Board of Architectural Review

DATE: July 18, 2018
TO: Board of Architectural Review Chair and Members
THROUGH: Jason Sutphin, Community Development Division Chief *(JDS)*
FROM: Tommy Scibilia, BAR Liaison *(TS)*
SUBJECT: Capstone

1. Case Number:	-
2. Address:	3807 University Drive
3. Request:	Multifamily development
4. Applicant:	Capstone Collegiate Communities, LLC
5. Applicant's Representative:	Robert Brant
6. Status of Representative:	Agent
7. Current Zoning:	CR Commercial Retail
8. Proposed Zoning:	PD-R Planned Development Residential, Old Town Fairfax Transition Overlay District

DESIGN NARRATIVE

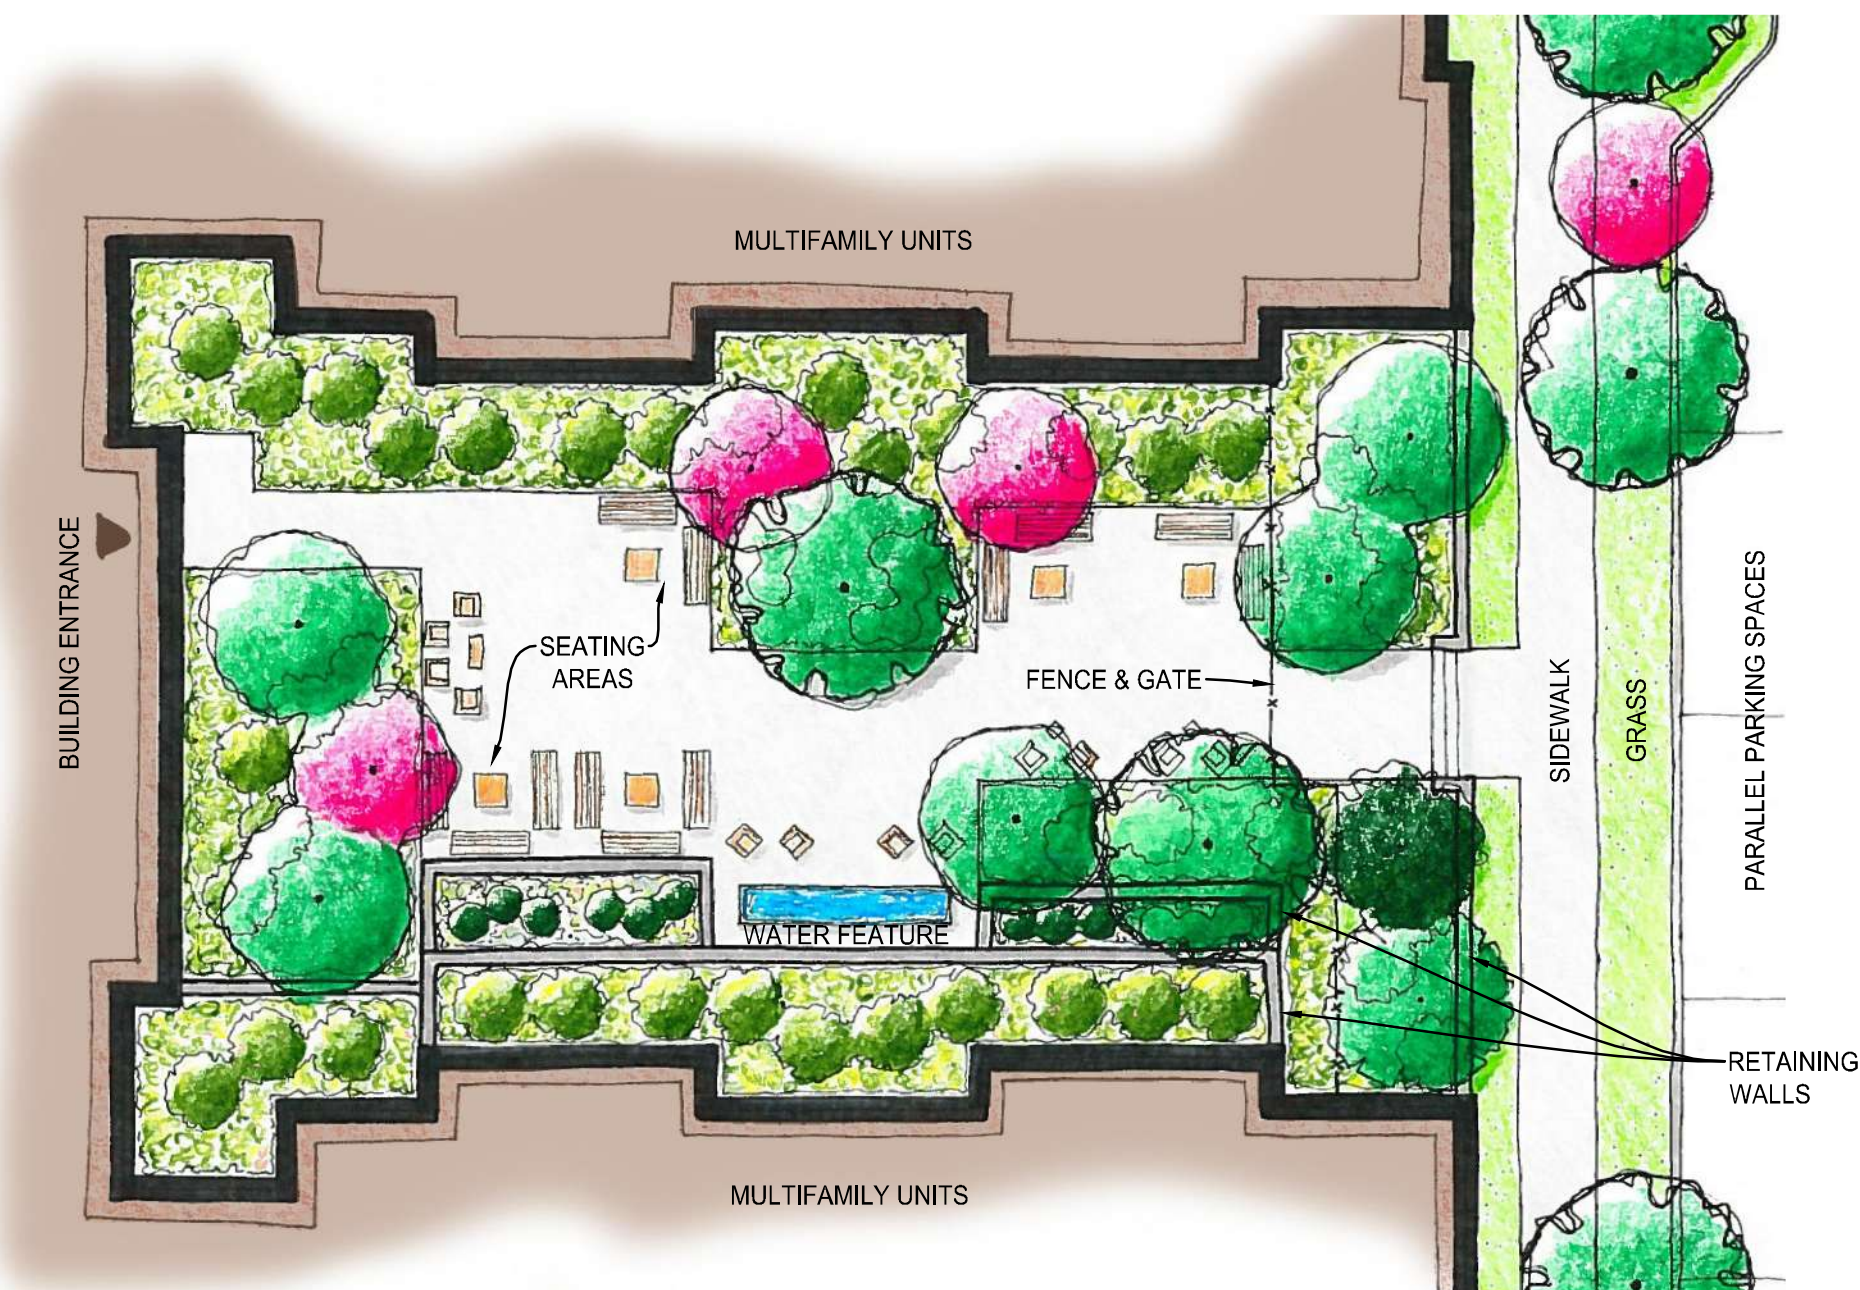
The applicant has included brick pavers in the landscape package (Attachment 3, sheet 4), proposed in certain locations, such as at sidewalk connections and plazas. Plain scored concrete would be used for the majority of hardscaping on site.

The applicant has included two lighting fixtures in the landscape package (Attachment 3, sheet 4), the City standard acorn light and a decorative gooseneck pole fixture. Specific locations are not called out on the plans. The Comprehensive Plan encourages the use of decorative gas fixtures in the Transition Overlay District, see provisions below in the analysis section. Information on other forms of lighting, such as landscape and building accent lighting, and building-mounted lighting have not been provided at this time.

The applicant has included images of the proposed benches and trash receptacles, both of which would have a matching stainless steel finish (Attachment 3, sheet 4). These would be located along the sidewalks at the periphery of the building and within the courtyards, although specific locations have not been indicated at this time. Other amenities include an outdoor kitchen and cabanas for use by the pool in the internal courtyard in the west portion of the building, however this would not be visible

University Dr Elevation

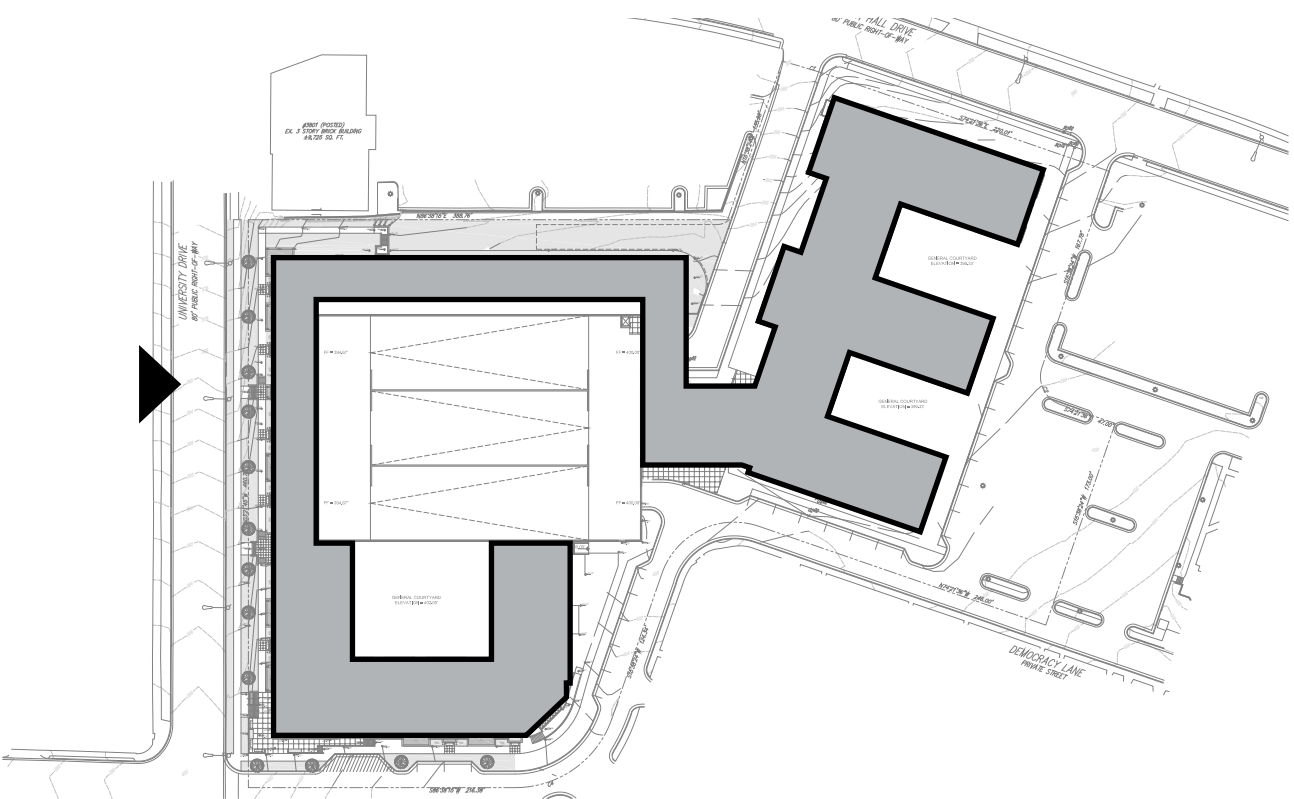
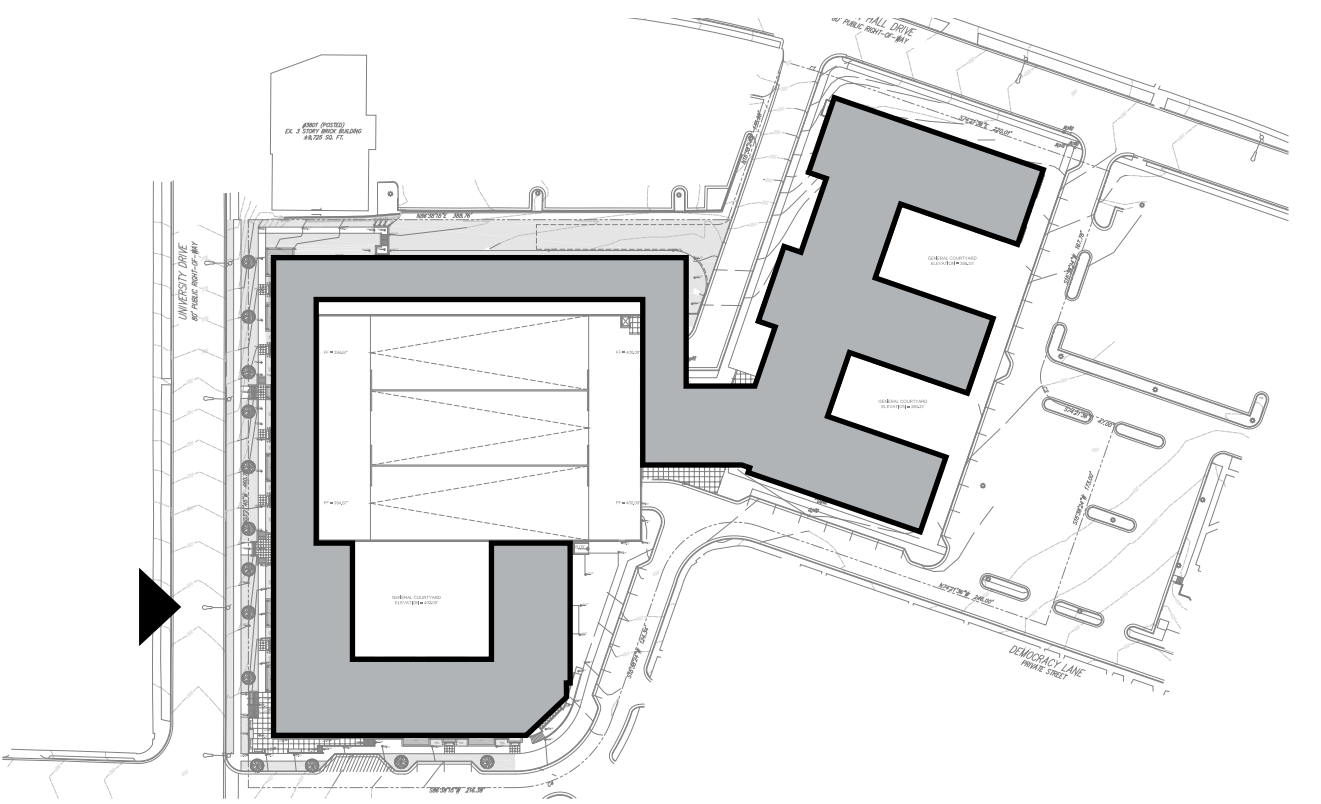
The building, while articulated in such a way as to mimic the width proportions of townhouses, consistent with the proportions of the Olde Town Mews across University Drive, further articulation is still needed. The building imposes an inappropriately large, unbroken mass along University Drive not consistent with the Olde Fairfax Mews. See further discussion below.

The proposal is not consistent with this guideline along University Drive. The scale of the building, while articulated in subtle ways with material variations, small jogs, and porches, is still quite massive. The approximately 250-foot length of the building along University Drive should incorporate more significant and meaningful forms of articulation, such as deep setbacks to create pocket parks or plazas that create pedestrian-scale relief. The material variation is also repetitive in nature. The Olde Fairfax Mews across the street incorporate different materials, architectural features, and accent colors that help create a unique identity for each home, even while the width of the units along the road is consistent. Further, there are large breaks in the street wall on this side of University, where pedestrian scale landscaped walkways and plazas between townhouse sticks are used to create an intimate environment and break up the massing of the development. The Layton Hall Drive facade and eastern legs of the building are proposed at the full height of five stories. In addition to the above considerations, the applicant should consider reducing the height of these facade elevations where practicable.
